October 8, 2015

Re: The Cove Apartments Completeness Response for
CP 15-01: Concept (Master) Plan Amendment
DP 15-01: Detailed Development Plan
NR 15-05: Natural Resources Overlay District Review
US 15-06: Geologic Hazards Overlay District Review

ENGINEERING COMPLETENESS ITEMS:

CP 09-02 Approved
Main Street Shed
Section

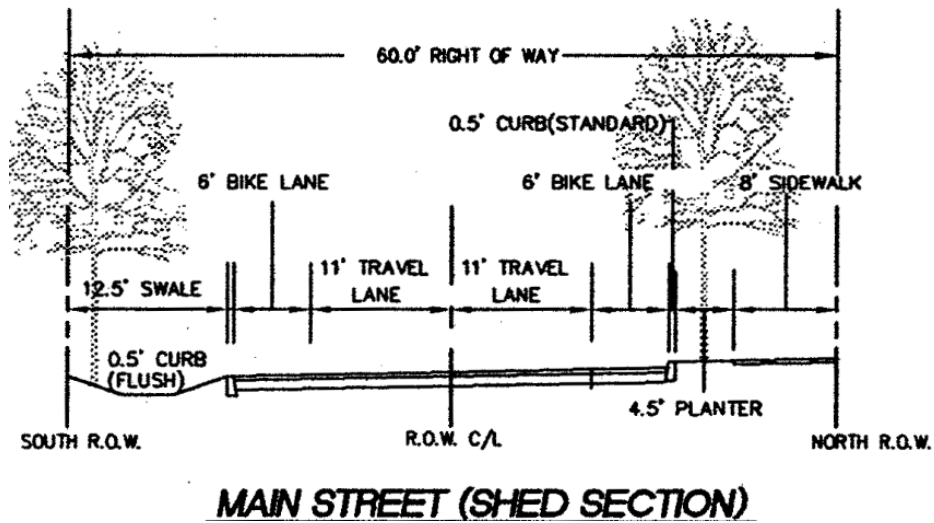
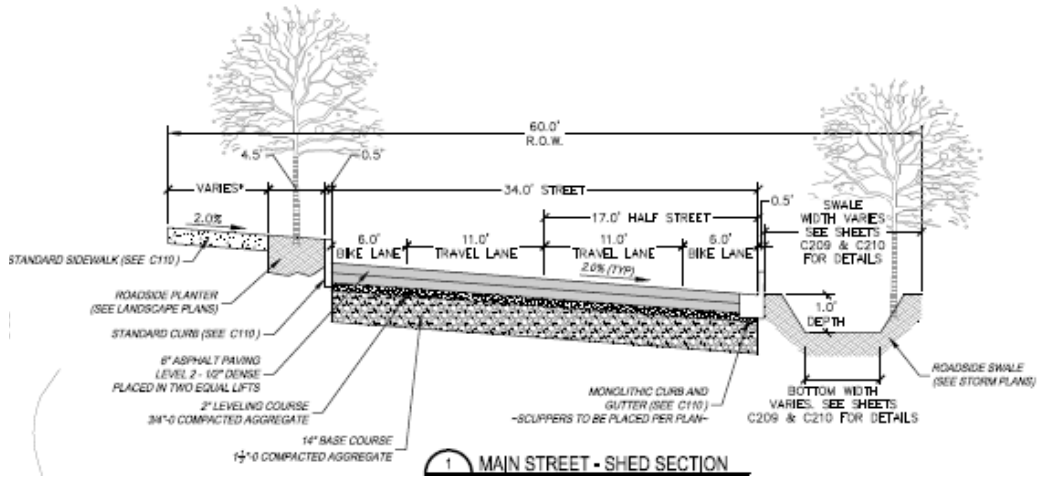
1. Please coordinate 12.04.007, 12.04.180, and 12.04.265. It is not clear what is being proposed for the street system. The narrative needs to address modifications to the standards set forth in the Code, with justification. The narrative only provides proposed sections as compared to “previous approvals.” Further, the proposed sections are addressed per “Crown Section” and “Shed Section,” but there is no corresponding drawing to indicate where the sections are located.

Response: The proposed street sections represent very minor changes from the cross sections approved under CP 09-02. Although the phasing of public road improvements has changed from previous approvals, Main Street and Agnes Street will remain predominantly the same as approved by the City, with a few minor changes:

- the landscape planter strip on the Main Street crown section has been reduced from 6.5-feet to 4.5-feet and the sidewalk width has been increased from 6-feet to 10-feet;
- a crown section for Agnes Street is no longer proposed; and,
- The extension of Agnes Street to Washington, as completed in Phase 2, would be a 12-foot paved path with 4-foot gravel shoulders (as compared to a 20-foot paved path conditioned with CP 09-02). The Agnes Avenue connection to Washington Street would be for emergency vehicles only, would be separated from the north park access by removable bollards and would also serve as a multi-use path.

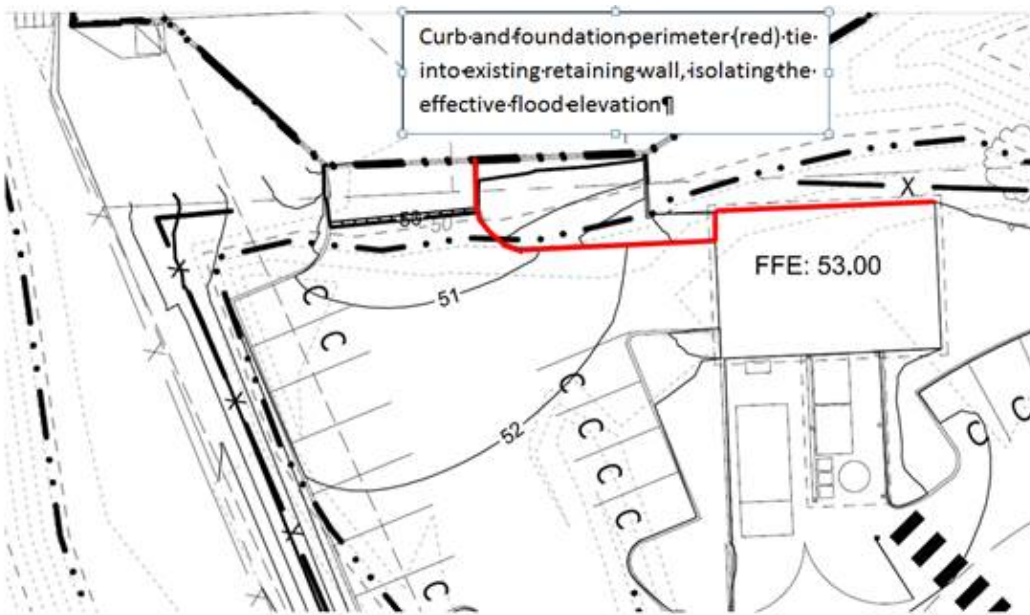
2. The emergency access design has not been addressed. The design provided is inadequate to determine if it is constructible. The access is shown going through a flood wall that is several feet in height.

Response: As shown on Sheet C3.1 of the DDP set, the foundation of the maintenance shed building and adjoining curb provide a continuous obstruction above flood elevation and will tie into the existing floodwall. These features, along with imported fill and grading on the site will ensure that floodplain areas north of the accessway are isolated and the flood retention function of the remaining wall will be preserved. The image below illustrates what this project element.
